Title: The Rock

Case No.#: **SIT-2026-0074** Meeting Date:

Re: The Rock: Site Plan Submittal

Site Plan Review Comment Responses
The Rock

A1 PROPOSED SITE PLAN

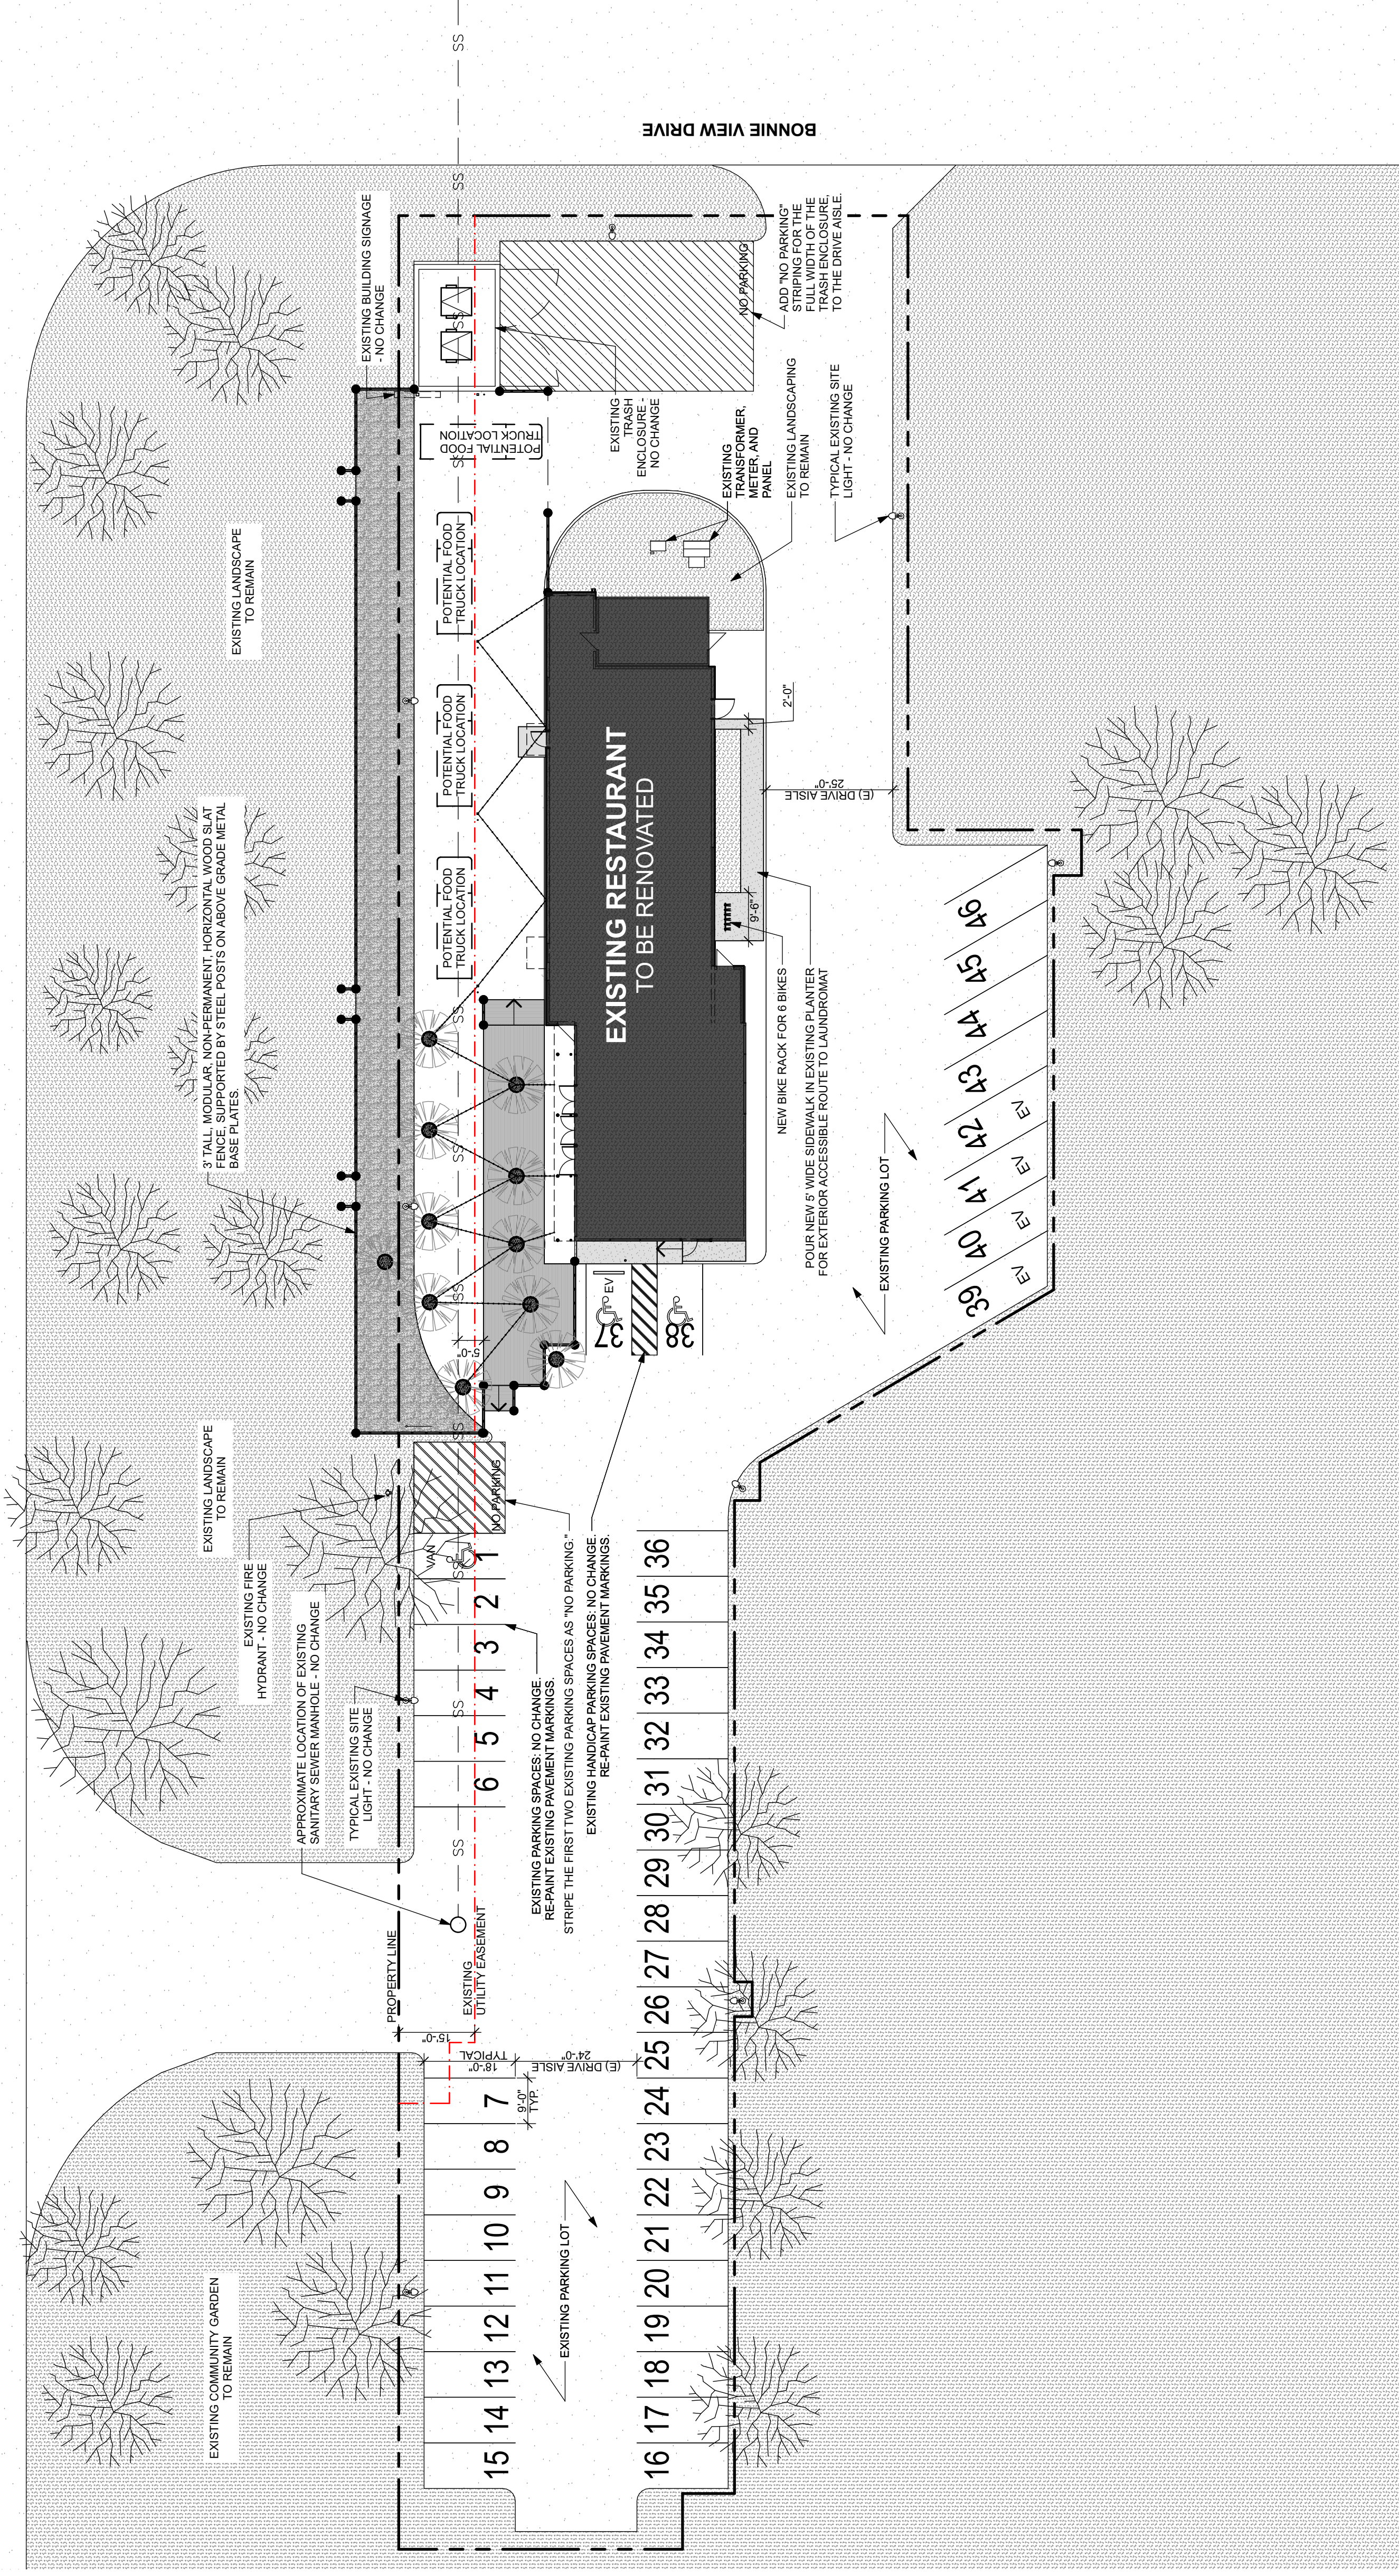
Fire hydrant access conflict with parking

The proposed deck and food trucks alter circulation and may affect access

Structures cannot be constructed over utility infrastructure or easements. The proposed deck occupies a utility easement and obstructs a wastewater line

Proposed work extends north beyond the development property line onto county property

Given the other comments above which will impact parking, please recalculate required accessible parking spaces

Parking spaces #1 and 2 have been marked as “no parking.” The parking spaces numbers have been updated, and the parking calculations have been updated accordingly.

Former parking spaces 49, 50, and 51 have been converted to “no parking.” The parking calculations have been updated accordingly.

The removable deck has been reduced in size to avoid the easement.

The owner will apply for an Encroachment Permit.

Per IBC (2021) Table 1106.2, for 46 parking spaces, 3 accessible parking spaces are required, of which one must be a van parking space. In addition to the two accessible parking spaces previously shown, one additional accessible van parking space has been provided at parking space #1. Please see the site plan.
